## Rugby Borough Council, Warwickshire County Council

### RBC Strategic Transport Assessment

## RUGBY LOCAL PLAN REG 19 SUBMISSION – RESPONSE TO NH REVIEW OF TRAFFIC MODELLING EVIDENCE

## A.1 National Highways Review of Rugby Local Plan Reg 19 Submission Modelling

**Figure 1 Route 16 Journey Path by Section**

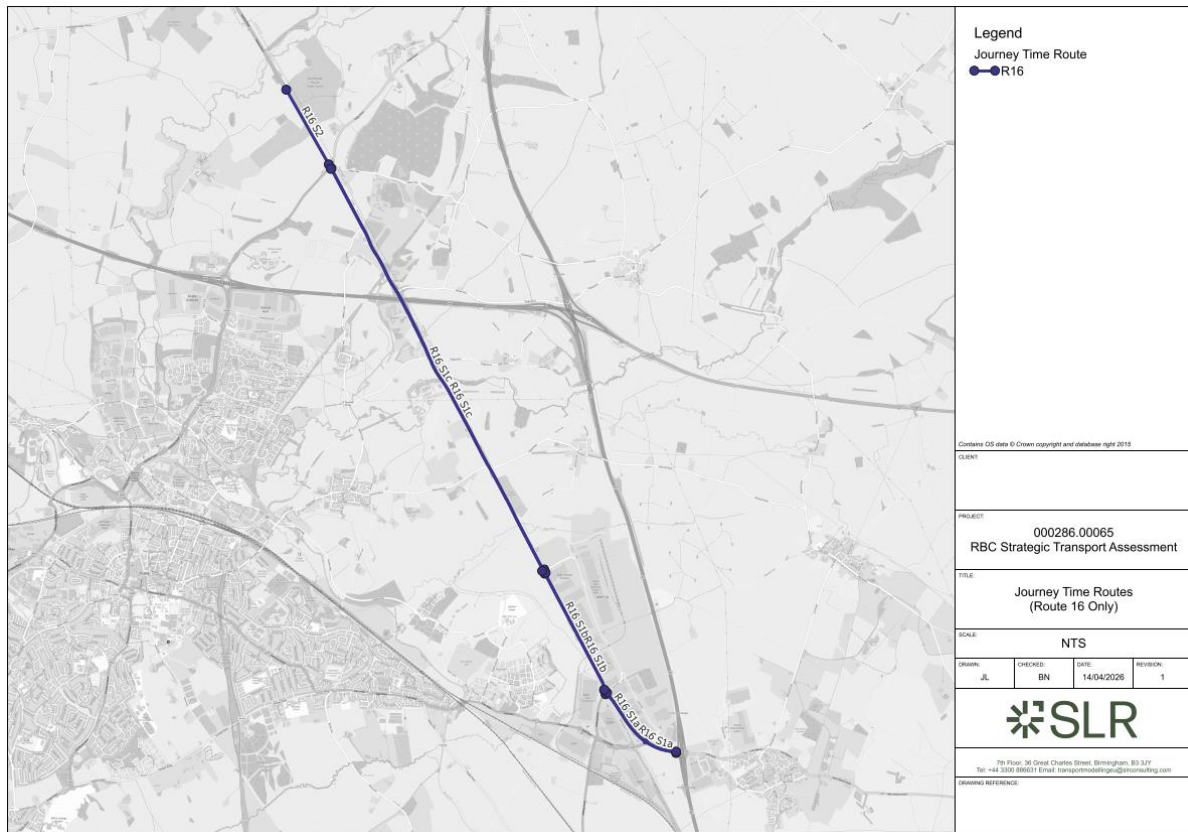
*Disaggregate the A5 northbound and southbound journey time routes to allow clearer interpretation. It is currently not possible to determine the true journey time impacts, particularly northbound, due to the removal of impedance at the A426/A5 Gibbet Hill junction in the Do Something scenarios*

3.2 Accordingly, SLR have broken Route 16 (reflecting the A5 corridor) down into 4 sections, as shown within the following **Figure 1**, and presented outputs for these revised journey time sections within the updated results spreadsheet<sup>3</sup> issued alongside this response. SLR assume that this will provide the additional detail regarding the reporting of impacts on this route required by NH, but can provide further information beyond this if this would be helpful.

**Figure 2 A5/Smockington Lane Junction – Delays from Right Turning Vehicles**

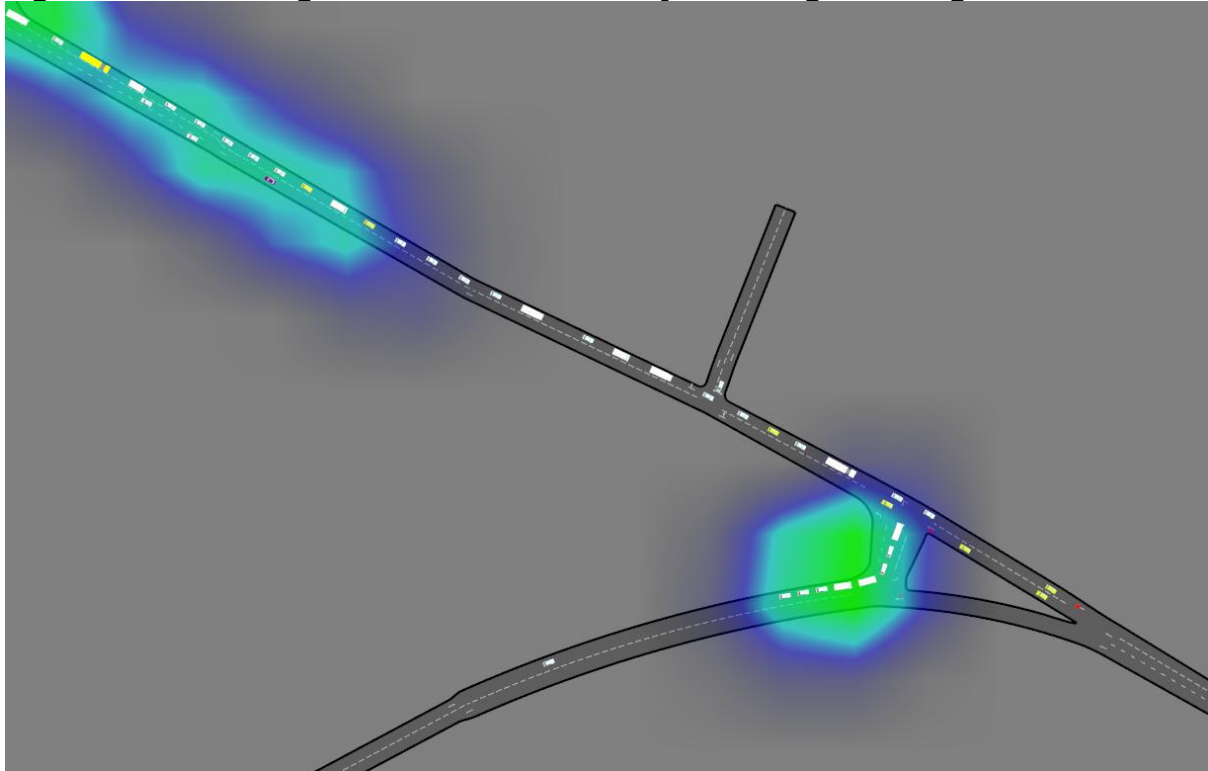
*Investigate the A5 eastbound journey time reduction in the RRAM (Section 1: M69 J1-B4114). The reduction observed in the Do Something scenario is not explained*

- 3.3 SLR have investigated the differences in reported modelled journey times between the 2042 RRAM Reference Case and 2042 Do Something scenarios on Route 7 Section 1 EB (A5 eastbound), based upon the original model runs reported.
- 3.4 Snapshots have indicated that this route experiences delays but that any queues that do form dissipate quickly. This delay is occurring at the right turn movement at the A5/Smockington Lane junction, with vehicles on the A5, waiting for a gap in oncoming traffic before making the right turn into Smockington Lane. During the busiest periods queues build up behind the vehicle that is waiting for the gap in oncoming traffic to make this movement, this is demonstrated within the following figure.

- 3.5 It is apparent that this is an issue that occurs sporadically, and impacts are short-lived, i.e. the queues dissipate once the vehicle waiting to turn right has made the movement. It is also apparent that this is not a consistent issue across the model simulation, and doesn't appear to occur in every run, moreover it is occurring when a particularly hesitant vehicle is waiting to make the movement.

**Figure 5 A45/Potsford Dam Link – AM Peak Hour Link Flow Difference Plot – Do Nothing vs Do Something Scenario**

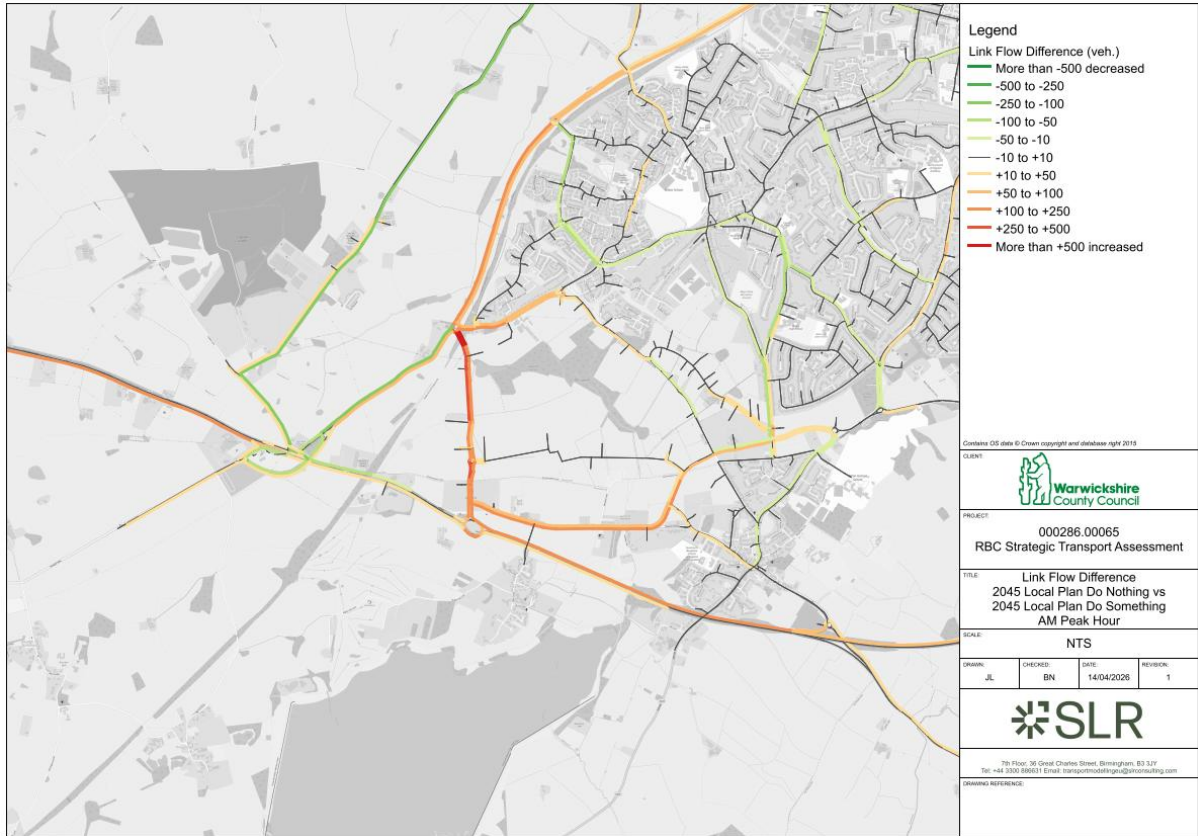
*Provide further explanation for the apparent reduction in flows along the A45 in the Do Something scenario*

- 3.10 The reduction in traffic flows on the A45 (between the Thurlaston and Blue Boar interchange) occurs in the Do Something scenarios, relative to the Do Nothing scenarios, as a direct result of the mitigation scheme included at the A4071/Potsford Dam Link roundabout.

- 3.14 To help demonstrate this, a flow difference plot is provided within **Figure 5**, which shows the differences in AM peak hour link flows between the Do Nothing and Do Something scenarios around the part of the network concerned. In addition to this **Figure 6** and **Figure 7** provide a further visual with annotation of the re-assignment occurring.

**Figure 3: Route 16 and 17 Journey Times Comparisons**

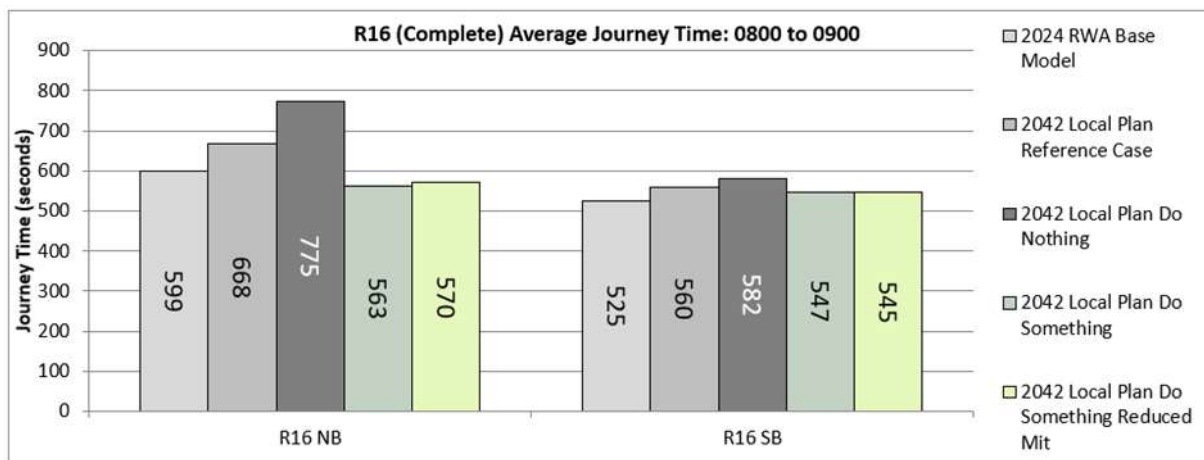
However, further examination shows that the A426/A5 Gibbet Hill junction has not been modelled in the Do Something scenarios. As a result, the full A5 journey time route (Route 16) is compromised and cannot be reliably used for comparison between

scenarios. The only section that can be meaningfully assessed is section 1 southbound, between the Gibbet Hill junction and M1 Junction 18. This section shows minimal change in the AM peak but a notable improvement in the PM peak, with approximately a three-minute reduction in journey time when comparing the Local Plan Do Nothing and Do Something scenarios. Given the increase in southbound flow, this represents a positive outcome for the SRN and the mitigation measures look to be working well.

**Figure 4: AM Google Traffic conditions compared to Base Model conditions**

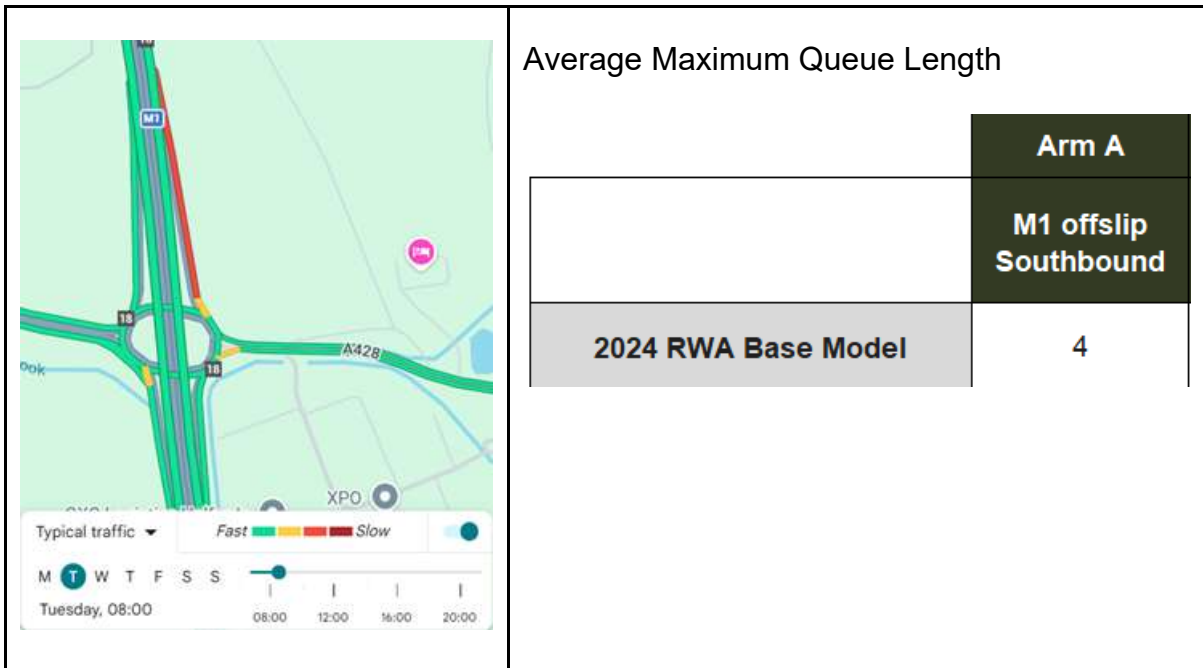
It should also be noted that the M1 Junction 18 grade-separated junction shows a significant improvement, with the M1 southbound off-slip experiencing a substantial reduction in AM peak queues, from 180 vehicles to 11 vehicles, reflecting the effects of signal optimisation. While Google traffic data (with the usual caveats) suggests that this approach typically experiences long delays, the 2024 Base model indicates only a short queue as shown below. When signal optimisation forms part of the proposed mitigation, it is essential that the baseline model is robust. A well-calibrated and validated LINSIG model should therefore be used to assess any proposed signal adjustments and verify their feasibility. This requirement applies to all locations where signal optimisation has been included as part of the mitigation package.

**Figure 7: Route 1 and 7 Journey Times Comparisons**

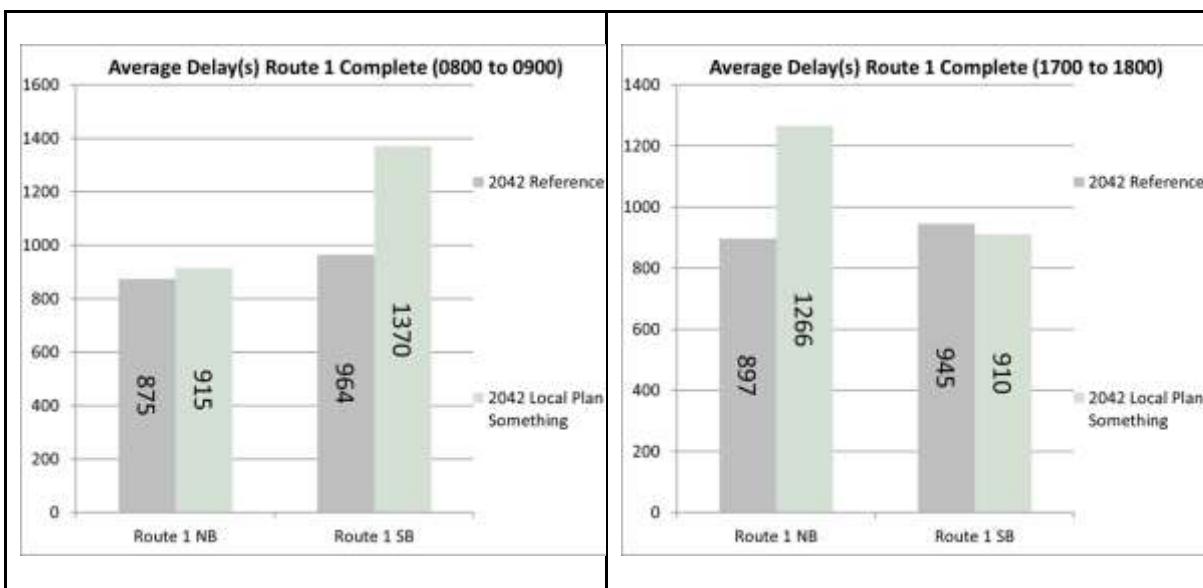
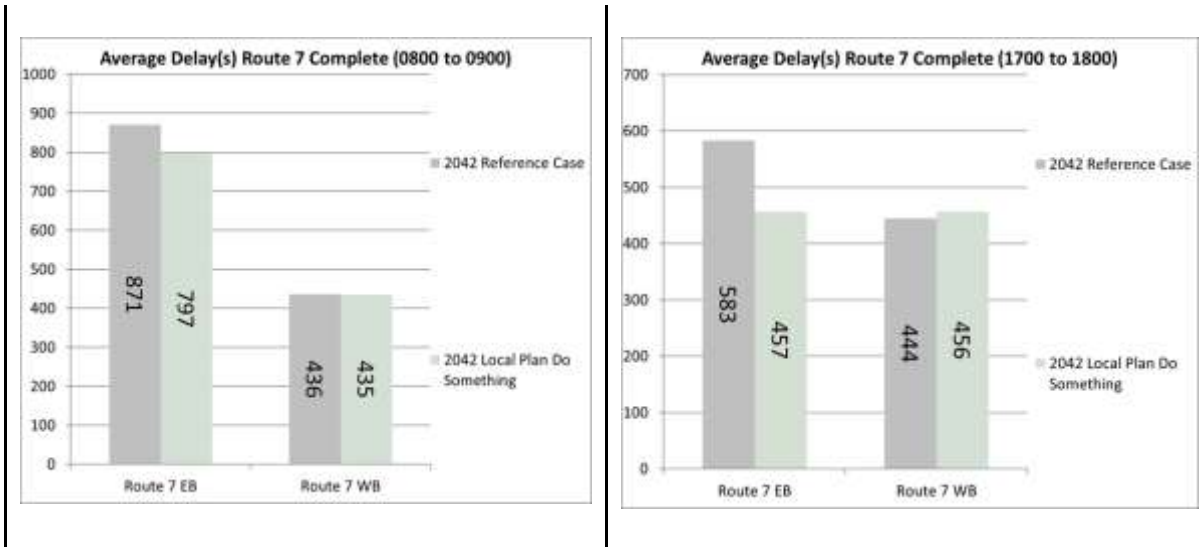
There are two key SRN routes within the model: the M69/A46 (Route Reference R1) and the A5 (Route Reference R7). The M69/A46 corridor experiences an increase in journey times during both the AM and PM peak periods, with the exception of the southbound direction in the PM peak. In contrast, the A5 corridor shows generally improved journey times across both peaks, with all but one movement experiencing an increase, a marginal increase of around 12 seconds in the PM westbound direction.

A particularly notable improvement occurs on the A5 eastbound in both peak hours, it is not clear why there is such a significant reduction in journey time in the Local Plan model, a more detailed look into the journey time section indicates that Section 1, between M69 J1 and B4114 Smockington Lane, sees around a 2 minute time saving, given there is no mitigation measures proposed here. Further information / investigation required.
